Transmitted by the experts from Germany

Informal document GRE-85-23
(85th GRE, 26-29 October 2021,
Item 4 (e) of the agenda)

**Proposal for a new supplement to the 06, 07 and 08 series of amendments to UN Regulation
No. 48**

This informal document is an additional proposal to GRE/2021/16. Modifications are **yellow**.

Visibility of a red lamp to the front and visibility of a white lamp to the rear

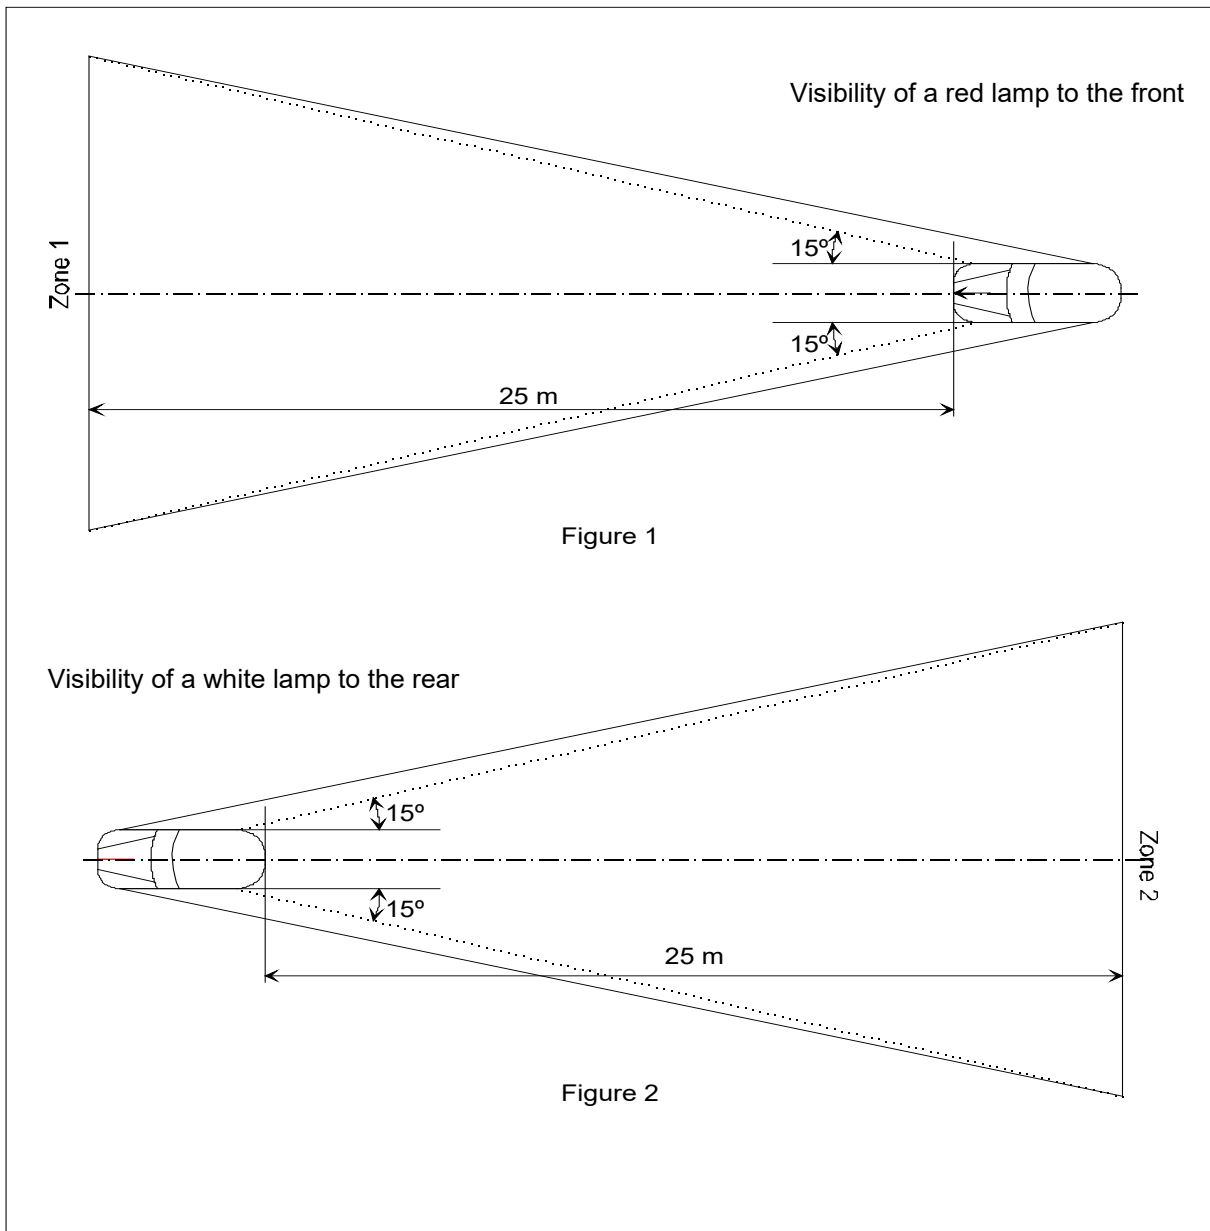
Annex 4, amend to read:

(See paragraphs ~~5.10.1. and 5.10.2.~~ **5.10.4.** of this Regulation)

In their respective planes, the zones 1 and 2 explored by the eye of the observer are bounded:

- In height, by two horizontal planes 1 m and 2.2 m respectively above the ground;
- In width, by two vertical planes which, forming to the front and to the rear respectively an angle of 15° outwards from the vehicle's median longitudinal plane, pass through the point or points of contact of vertical planes parallel to the vehicle's median longitudinal plane delimiting the vehicle's overall width; if there are several points of contact, the foremost shall correspond to the forward plane and the rearmost to the rearward plane.”

Visibility of a red lamp to the front and visibility of a white lamp to the rear

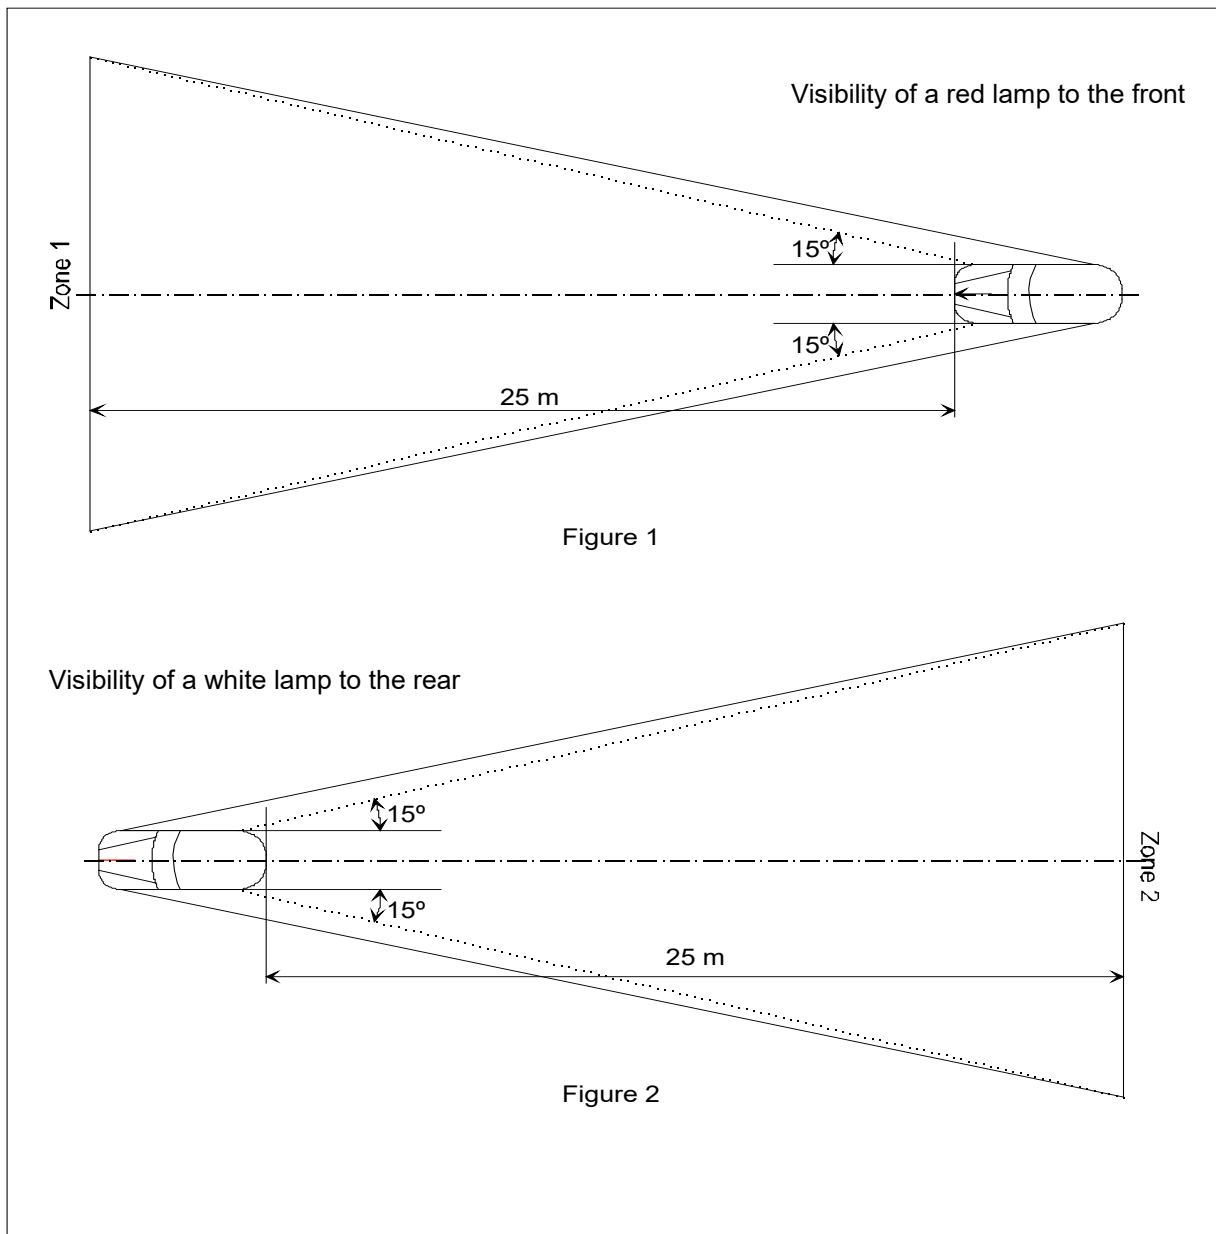
Annex 4, amend to read:

(See paragraphs ~~5.10.1. and 5.10.2.~~ **5.10.4.** of this Regulation)

In their respective planes, the zones 1 and 2 explored by the eye of the observer are bounded:

- **In height, by two horizontal planes 1 m and 2.2 m respectively above the ground;**
- **In width, by two vertical planes which, forming to the front and to the rear respectively an angle of 15° outwards from the vehicle's median longitudinal plane, pass through the point or points of contact of vertical planes parallel to the vehicle's median longitudinal plane delimiting the vehicle's overall width; if there are several points of contact, the foremost shall correspond to the forward plane and the rearmost to the rearward plane."**
